## HISTORIC PRESERVATION COMMISSION

SUBJECT: Historic Area Work Permit # 956436 - revisions to previously approved HAWP

# CEPHAS SUMMER HOUSE

Addendum 1  
Staff Comments Emailed to Applicants 12.5.23

PROJECT: THE SPENCE FAMILY  
DATE: 05/23/2023  
TYPE: DETACHED  
CEPHAS  
ARCHITECT  
PLAN NO: 62  
PLOT: 62

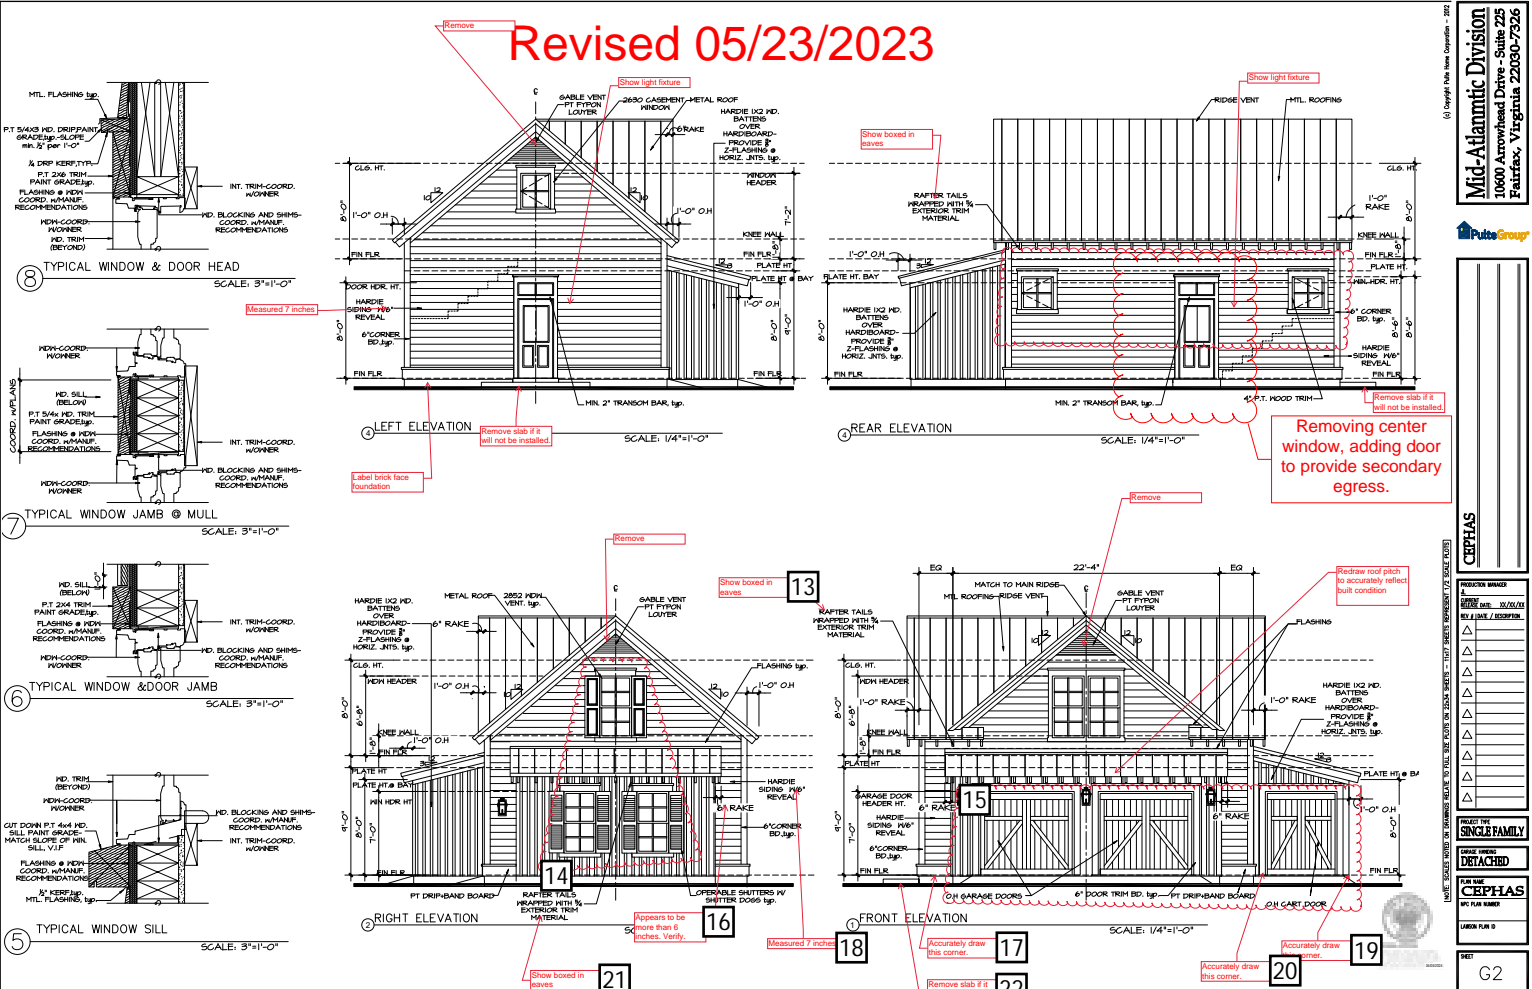
- Number: 1 Author: Christopher.Berger Subject: Callout Date: [unreadable]  
As part of the revised HAWP, remove the upper gable end vents from all locations. Include photographs of as-built conditions.

- Number: 2 Author: Christopher.Berger Subject: Callout Date: 12/5/2023 8:01:41 AM  
As part of the revised HAWP, show the location and specifications for all light fixtures.

- Number: 3 Author: Christopher.Berger Subject: Callout Date: 12/5/2023 8:01:46 AM  
As part of the revised HAWP, show the location and specifications for all light fixtures.

- Number: 4 Author: Christopher.Berger Subject: Callout Date: 12/5/2023 8:01:53 AM  
As part of the revised HAWP, amend the drawing/notes to show boxed-in eaves.

- Number: 5 Author: Christopher.Berger Subject: Polygon Date: 12/5/2023 8:02:03 AM  
As part of the revised HAWP, accurately show all 3 windows on the rear elevation.

- Number: 6 Author: Christopher.Berger Subject: Callout Date: 12/5/2023 8:02:19 AM  
As part of the revised HAWP, submit an amendment for the siding (7" exposure instead of 6" exposure).

- Number: 7 Author: Christopher.Berger Subject: Callout Date: 12/5/2023 8:02:24 AM  
As part of the revised HAWP, remove the slab if it will not be installed.

- Number: 8 Author: Christopher.Berger Subject: Callout Date: 12/5/2023 8:02:31 AM  
As part of the revised HAWP, remove the slab if it will not be installed.

- Number: 9 Author: Christopher.Berger Subject: Callout Date: 12/5/2023 8:02:41 AM  
As part of the revised HAWP, label and submit specifications for the brick veneer on the foundation.

- Number: 10 Author: Christopher.Berger Subject: Callout Date: 12/5/2023 8:02:46 AM  
As part of the revised HAWP, remove the upper gable end vents from all locations. Include photographs of as-built conditions.

- Number: 11 Author: Christopher.Berger Subject: Callout Date: 12/5/2023 8:02:53 AM  
As part of the revised HAWP, remove the upper gable end vents from all locations. Include photographs of as-built conditions.

- Number: 12 Author: Christopher.Berger Subject: Callout Date: 12/5/2023 8:02:57 AM  
As part of the revised HAWP, amend the roof to reflect the as-built condition (if needed).

- Number: 13 Author: Christopher.Berger Subject: Callout Date: 12/5/2023 8:03:02 AM  
As part of the revised HAWP, amend the drawing/notes to show boxed-in eaves.

- Number: 14 Author: Christopher.Berger Subject: Polygon Date: 12/5/2023 8:03:06 AM  
Staff recommends that the applicant omit all shutters on the right elevation. Of note, the approved plans call for "operable shutters with shutter dogs." Therefore, if installed, the shutters should not be bolted to the siding.

- Number: 15 Author: Christopher.Berger Subject: Polygon Date: 12/5/2023 8:03:12 AM  
As part of the revised HAWP, change the design of the door to the as-built/approved door or add a note.

- Number: 16 Author: Christopher.Berger Subject: Callout Date: 12/5/2023 8:03:16 AM  
As part of the revised HAWP, field verify and amend the dimensions of the rake (if needed).

- Number: 17 Author: Christopher.Berger Subject: Callout Date: 12/5/2023 8:03:22 AM  
As part of the revised HAWP, amend the elevations to reflect the as-built condition.

- Number: 18 Author: Christopher.Berger Subject: Callout Date: 12/5/2023 8:03:26 AM  
As part of the revised HAWP, submit an amendment for the siding (7" exposure instead of 6" exposure).

- Number: 19 Author: Christopher.Berger Subject: Callout Date: 12/5/2023 8:03:30 AM  
As part of the revised HAWP, amend the elevations to reflect the as-built condition.

- Number: 20 Author: Christopher.Berger Subject: Callout Date: 12/5/2023 8:03:34 AM  
As part of the revised HAWP, amend the elevations to reflect the as-built condition.

- Number: 21 Author: Christopher.Berger Subject: Callout Date: 12/5/2023 8:03:38 AM  
As part of the revised HAWP, amend the drawing to show boxed-in eaves.

- Number: 22 Author: Christopher.Berger Subject: Callout Date: 12/5/2023 8:03:43 AM  
As part of the revised HAWP, remove the slab if it will not be installed.

1. All gable vents have been removed. Pictures can be found below.
2. Lighting locations can be found on the updated drawings. Specifications for the light are detailed in Exhibit 2.
3. Lighting locations can be found on the updated drawings. Specifications for the light are detailed in Exhibit 2.
4. The drawings have been updated to show the boxed-in eaves.
5. The drawings have been revised to accurately show all three windows on the rear elevation.
6. The drawings have been updated to show 7" siding exposure.

- 
7. The drawings have been updated to remove the slab at the door.
  8. The drawings have been updated to remove the slab at the door.
  9. The drawings have been updated to show the brick stamped foundation.

13. The drawings have been updated to show the boxed-in eaves.
  14. The shutters will be removed from the right elevation and the drawings have been updated accordingly.

16. The drawings have been updated to reflect the dimensions of the rake.
  17. The drawings have been updated to reflect the as-built condition.
  18. The drawings have been updated to show 7" siding exposure.

19. The drawings have been updated to reflect the as-built condition.
  20. The drawings have been updated to reflect the as-built condition.
  21. The drawings have been updated to show the boxed-in eaves.

22. The drawings have been updated to remove the slab at the door.
